10/631,049

Christoph Stefan Randazzo

Office Action Summary

DETAILED ACTION

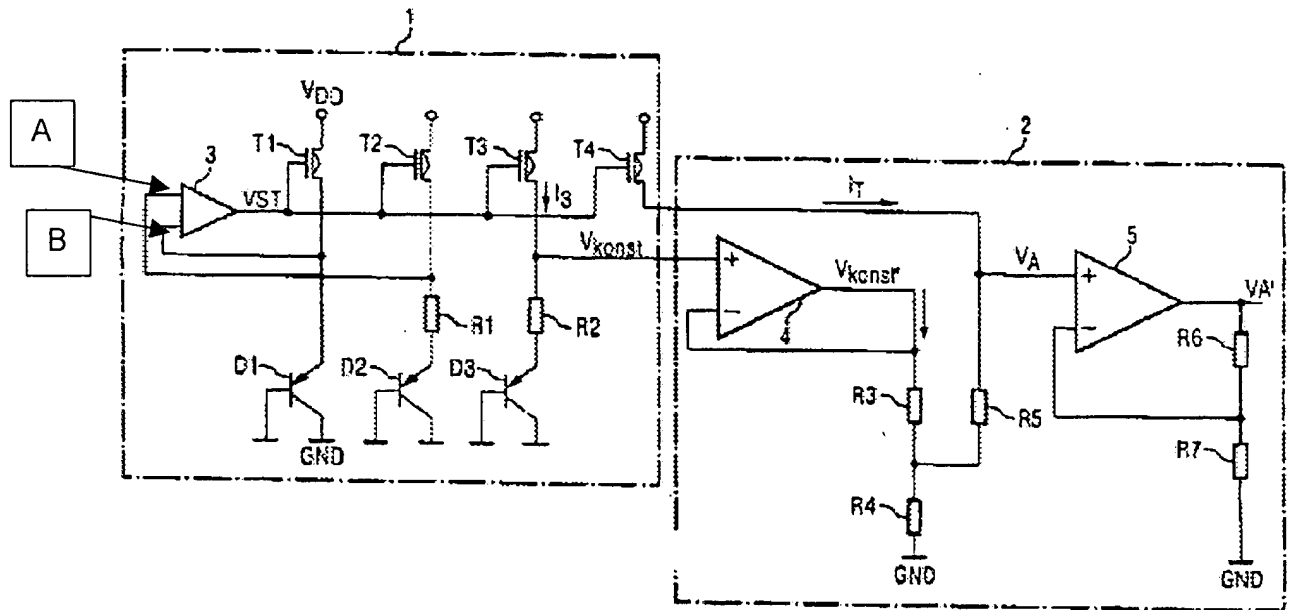
EGERER discloses or suggests all the limitations as claimed by Applicant in Claims 1-4, 9, 10 and 12-18, including an apparatus 1 for performing a temperature measurement function, comprising a first stage with a first circuit (D2, T2; see the Figure, reproduced on next page) and a second circuit (D1, T1) being arranged in parallel, said first circuit comprising a first transistor (T2), a first resistor (R1), and a parallel arrangement of n diodes (D2), said second circuit comprising a second transistor (T1) and a parallel arrangement of m diodes (D1), an operational amplifier (3) on the input side being connected to the first circuit and the second circuit, said operational amplifier (3) applying a gate voltage to said first transistor (T2) and said second transistor (T1), said apparatus 1, further comprising an output stage (2) with p output transistors (T4), and an output resistor (R5) performing a current to output voltage conversion (VA) in order to provide an output voltage that depends on the actual temperature as claimed by Applicant in Claim 1.

EGERER further discloses first transistor (T2) provides a first current flowing through the parallel arrangement n diodes (D2) and said second transistor (T1) provides a second current flowing through the parallel arrangement of m diodes (D1) as claimed by Applicant in Claim 2.

EGERER further discloses said operational amplifier 3 has a first input (not labeled in EGERER, but annotated "A" in reproduced Figure, above), a second input (annotated "B" in reproduced Figure, above), and an output (VST), the first input (A) being connected to a drain of the first transistor (T2) and the second input (B) being connected to a drain of the second transistor (T1), said output (VST) being connected to a gate of said first transistor (T2) and a gate of said second transistor (T1) for biasing these transistors (T2, T1) as claimed by Applicant in Claim 3.

EGERER further discloses said output stage 2 amplifies said[sic] first current to obtain a third current (I_T) before performing said current to output voltage conversion by converting said third current (I_T) into said output voltage (A) as claimed by Applicant in Claim 4.

EGERER further discloses the gate voltage is applied to gates of the p output transistors (T4) as claimed by Applicant in Claim 13.

EGERER further discloses a temperature compensation network (comprising elements R2 and D3) providing a bandgap reference voltage (V_{KONST}) at another output as claimed by Applicant in Claim 14.
